## **International Isotopes Inc.**

Subject: Request to Amend NR-1235-S-108-S.

JJM-2012-26

BMCY68 BOTTOM OPTION 1 (STANDARD)

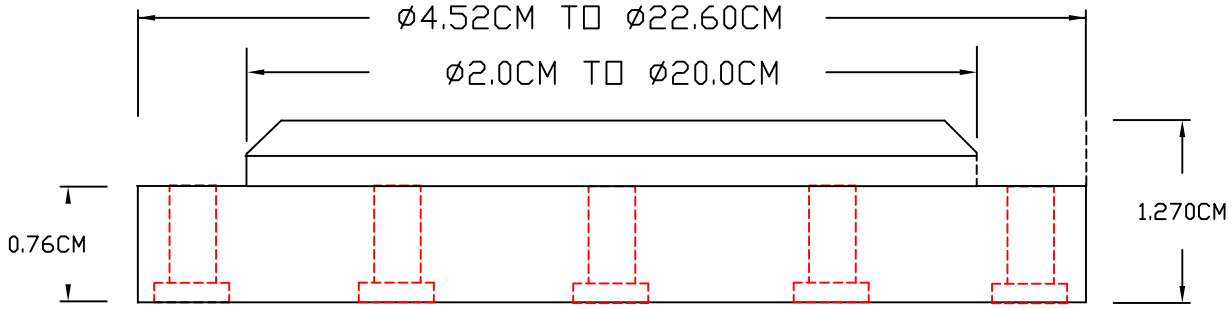
The new drawings that have been provided are more legible and include additional design detail. The BMCY68 Bottom Options drawing now restricts the thickness and configuration of the Model BMCY bottom to 3 options, as described below.

The standard bottom consists of a solid piece of high density polyethylene (HDPE) or equivalent whose diameter is defined by the cylinder body and fixed thickness. Note that in the standard configuration the bottom plate and top plate of the source would be of the same diameter and thickness.

BMCY68 BOTTOM OPTION 2 (SEIMENS ONLY)

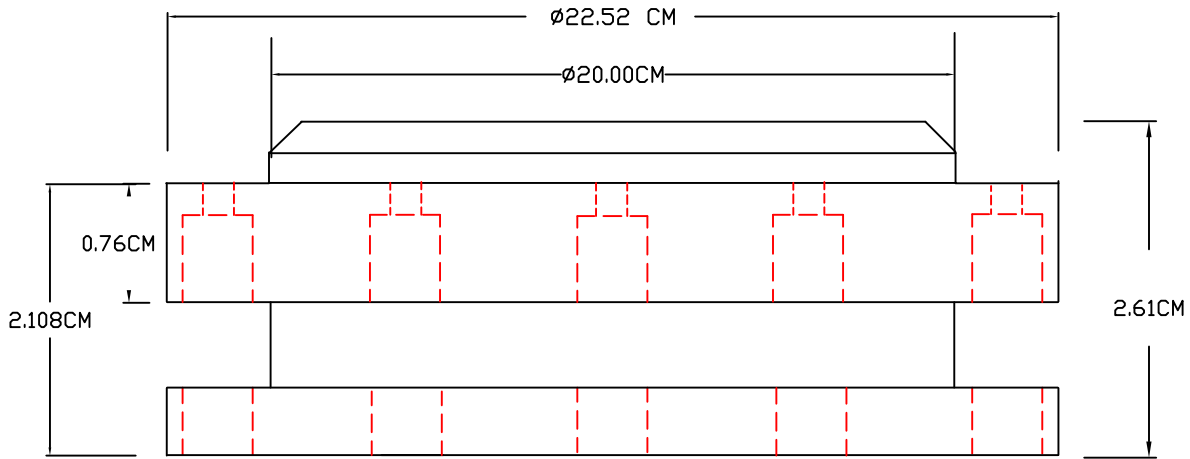
Bottom Options 2 and 3, also fabricated from HDPE or equivalent are within the minimum and maximum thickness of the current Model BMCY-68-DDHH-YY Source drawing (reference Attachment 1 of NR-1235-S-108-S) and are either machined with a groove (as indicated in Option 2) or female threaded connection (as indicated in Option 3) so that the source can be readily attached to the imaging device during calibration and reference testing.
